DESIGN REVIEW BOARD

Staff Report

File Number: 11-F-26-IH

Location: 1022 Crozier Ave. **Parcel ID:** 81 H C 011

ELEVATION EXHIBIT

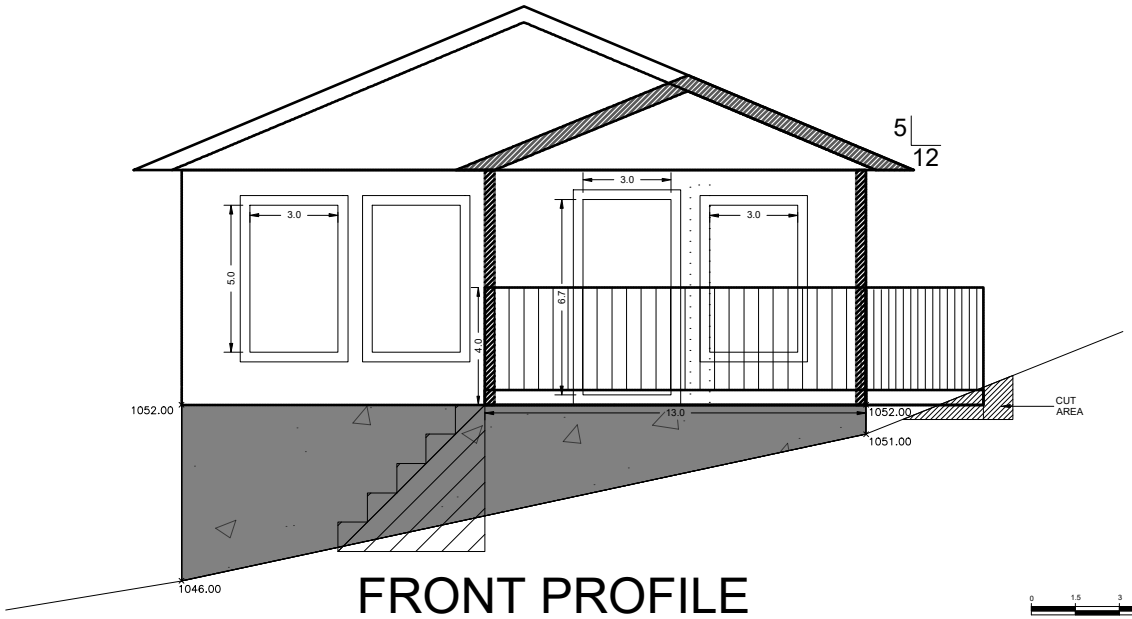
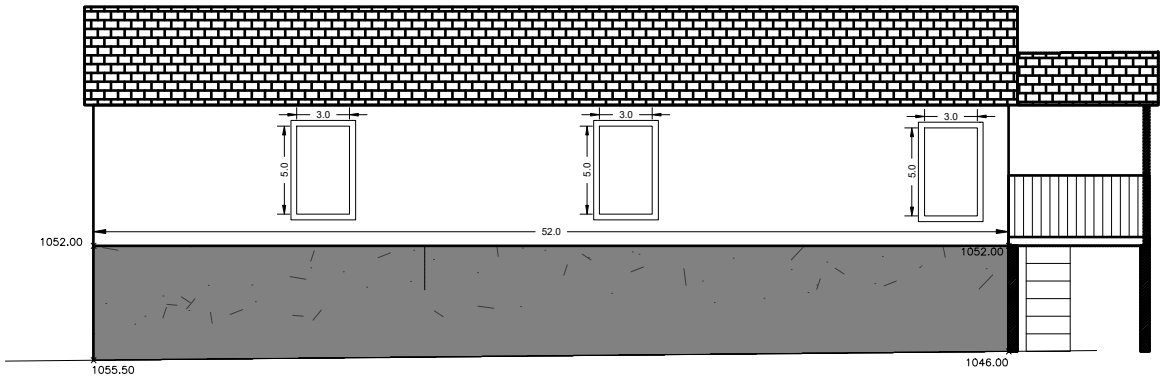
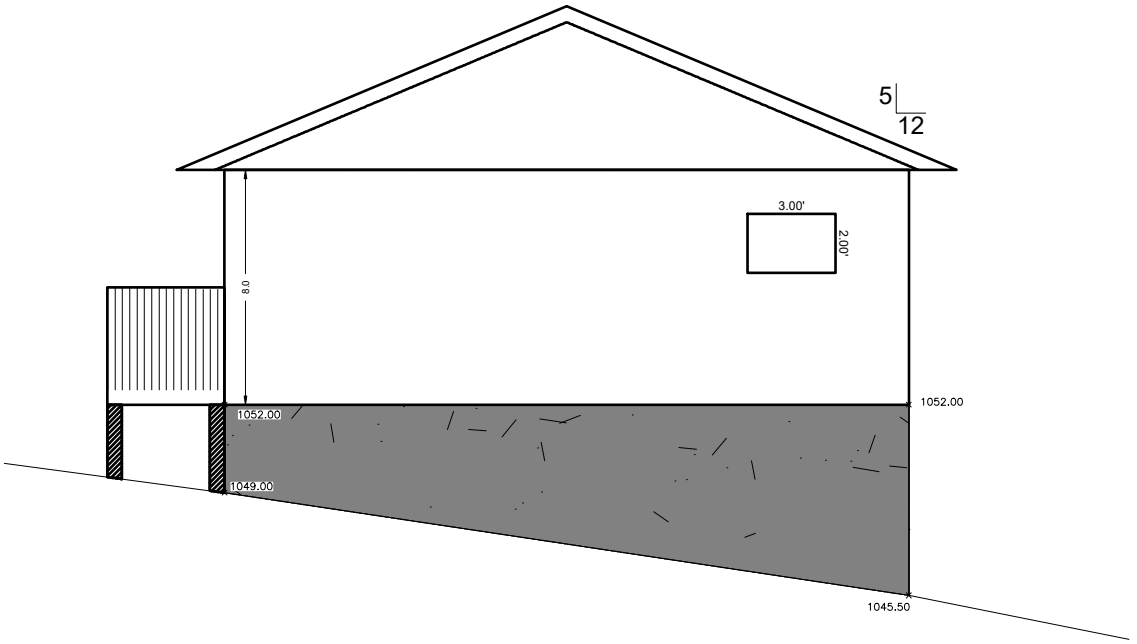
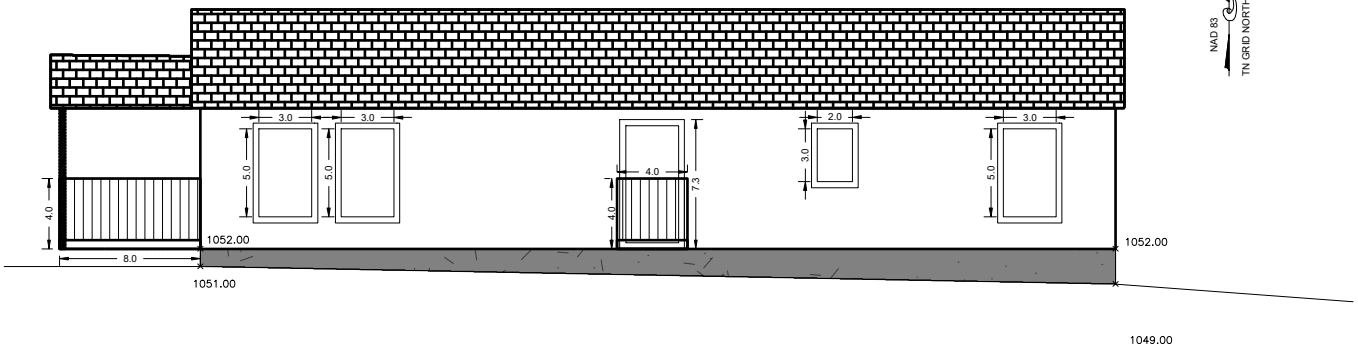
Scale, Mass, and Foundation Height: The house is approximately double the depth of the two existing Minimal Traditionals on the blockface, but it is similar to the 48’ deep (porch not included) house that was approved earlier this year for 910 Crozier Avenue. The proposed foundation height is appropriate given the slope of the lot and other houses on the block, and major changes will require further review by the Board. The cementitious stucco cladding should be retained.

Staff recommends approval of Certificate 11-F-26-IH, subject to the following conditions:
1) the final site plan to meet City Engineering standards;
2) major changes to the foundation height to return to the Board for review, and the cementitious stucco cladding to be retained;
3) retaining details as depicted, including but not limited to the porch header beam, minimum 6” by 6” turned porch columns, handrailing design, single-hung or double-hung window operation, trim at the base of gable fields, accent siding, and different siding colors from adjacent new construction.

EXTERIOR ELEVATIONS

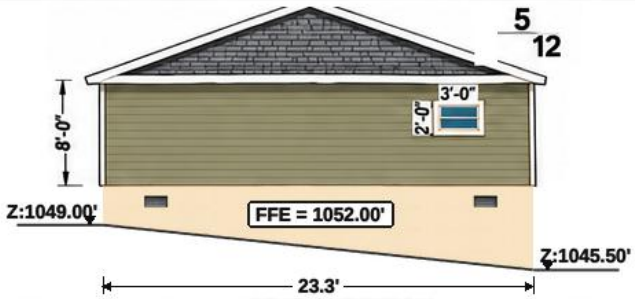
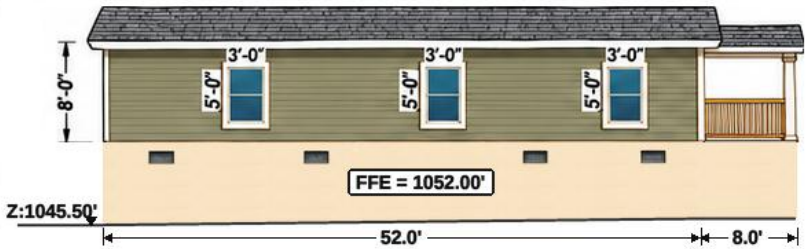
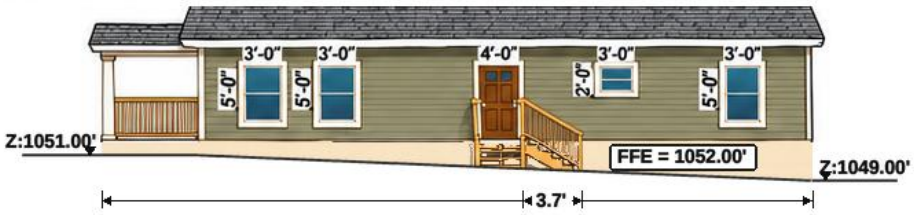
Porches and Stoops: Appropriate. The porch will be built on site. The header beam, handrailing details, and turned columns should be retained, and the columns should be at least 6” by 6”. The porch width and placement differentiates it from the adjacent new construction.

Roof Shapes and Materials: The 5/12 pitch does not meet the 6/12 minimum typically approved within the overlay, and it cannot be increased for this multi-sectional plan. The Board has approved a multi-sectional home with a 5/12 pitch roof within the overlay that featured a similar front gable design with a site-built front porch (3-A-22-IH, 1506 Ohio Ave). Given the lack of context and additional design elements that align with guideline recommendations, the 5/12 pitch can be appropriate, as long as the trim at the base of the gable fields, accent siding, and porch details are retained. The Board should discuss whether other interventions are necessary.

Siding Materials: Appropriate. The accent siding and siding colors differentiate the house from the adjacent new construction and should be retained.
